SUBJECT: MILLSTONE UNIT 3 - ISSUANCE OF AMENDMENT (TAC NOS. 75312 & 75393)

AMENDMENT TO FACILITY OPERATING LICENSE

Amendment No. 47  
License No. NPF-49

ATTACHMENT TO LICENSE AMENDMENT NO. 47

FIGURE 3.6-2  
HYDROGEN RECOMBINER ACCEPTANCE CRITERIA  
FLOW VS CONTAINMENT PRESSURE

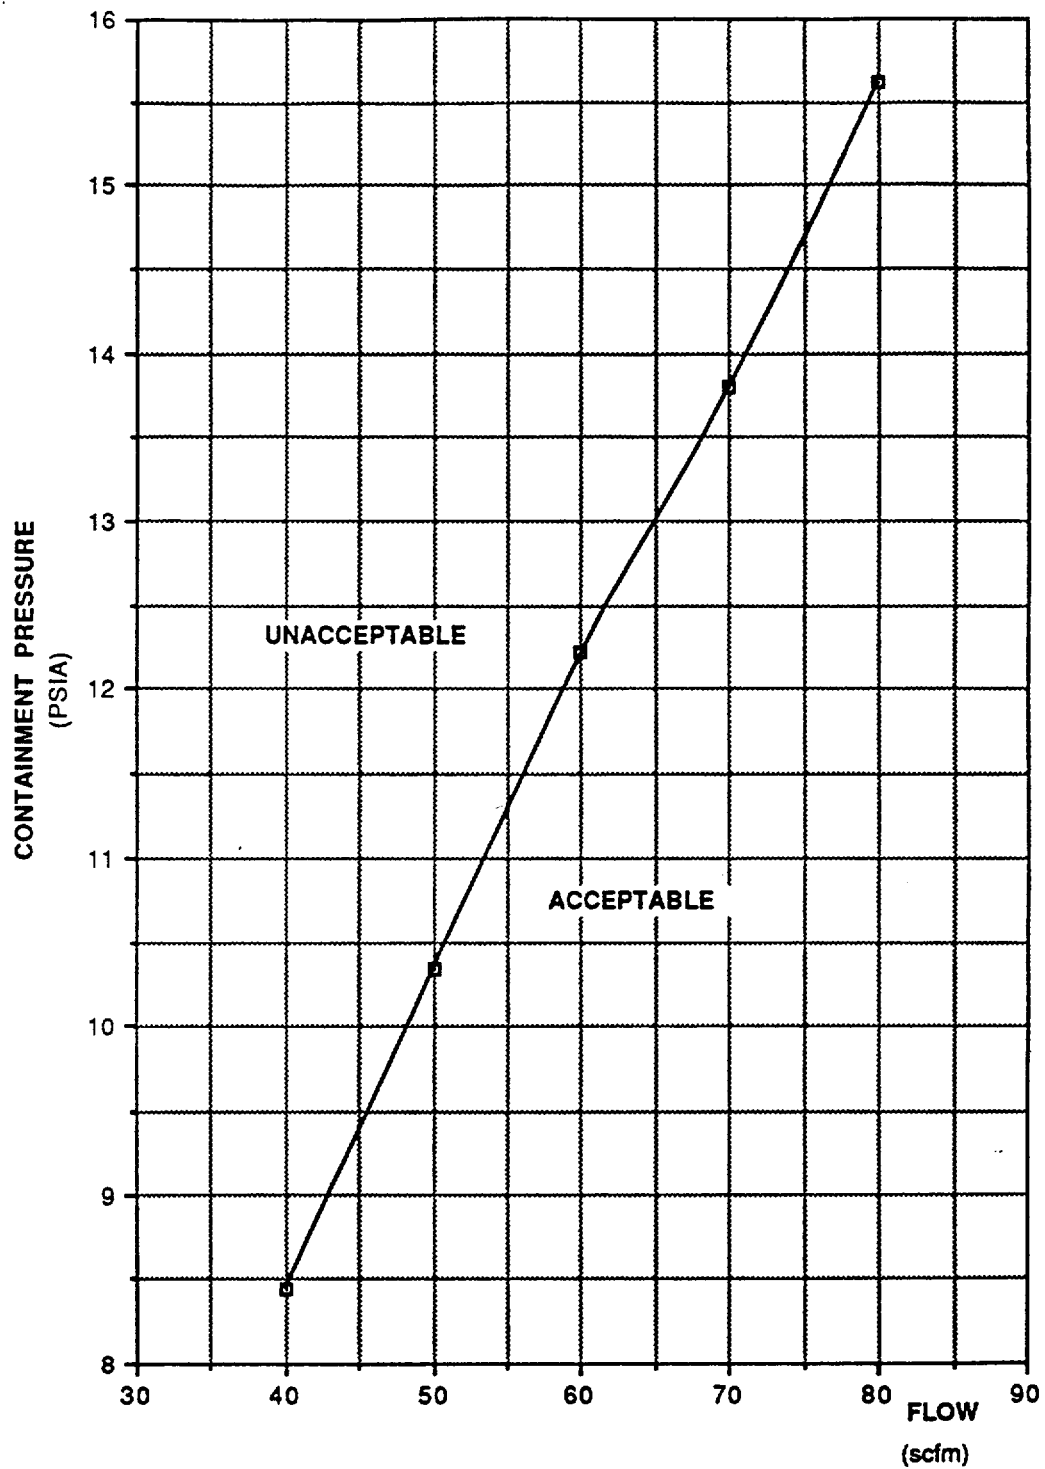
- 4) Verifying during a recombiter system functional test using containment atmospheric air at a flow rate of greater than or equal to that indicated on Figure 3.6-2, that the gas temperature increases to greater than or equal to 1100°F within 5 hours and is maintained for at least 4 hours.

Technical Specification 4.6.4.2b.4 requires that the licensee verify, every 18 months, that the hydrogen recombiners demonstrate a flow rate of at least 40 scfm. Although hydrogen recombiner flow rate is a function of containment pressure, the existing TS 4.6.4.2b.4 does not specify a containment pressure for performance of the hydrogen recombiner flow test.

During a recent review of hydrogen recombiner surveillance test data and the original calculation for post LOCA hydrogen generation inside containment, the licensee identified an inconsistency. Specifically, the original analysis assumed that 50 scfm of containment air would flow thorough the system while the containment pressure was at 9 psia in post-LOCA conditions. This assumed

flow rate is also greater than tested flow rates which have been as low as 42 scfm when containment is between 9 and 10 psia. Therefore, the licensee performed a new calculation and determined the minimum acceptable flow rate through hydrogen recombiners to be 40.5 scfm. This flow rate will still ensure containment hydrogen concentration remains below 4 volume percent during the accident if the hydrogen recombiners are started within 24 hours of a DBA when the hydrogen concentration of the containment atmosphere is at or below 1.8 volume percent. As stated in FSAR Section 6.2.5, the hydrogen recombiners would be started well before 1.8 volume percent hydrogen is detected in the containment.

The proposed change to TS 4.6.4.2b.4 would replace the 50 scfm acceptance criteria for the hydrogen recombiner flow test with an acceptance criteria that is a function of containment pressure. The proposed variable acceptance criteria range almost linearly from approximately 40 scfm at a containment pressure of 8.5 psia to approximately 80 scfm at a containment pressure of 15.5 psia. The lowest flow acceptance criterion, however, would be limited to approximately 51 scfm since the lowest containment pressure is limited to 10.6 psia by TS 3.6.4.1 as indicated in the licensee's letter dated January 19, 1990.

The proposed change to TS 4.5.4.2b.4 provides acceptance criteria for hydrogen recombiner testing which are adequate to demonstrate that the recombiners will perform their post-LOCA design function. Moreover, the acceptance criteria provide the flexibility to allow the licensee to test the recombiners over a range of containment pressures. Accordingly, the proposed change to TS 4.6.4.2b.4 is acceptable.
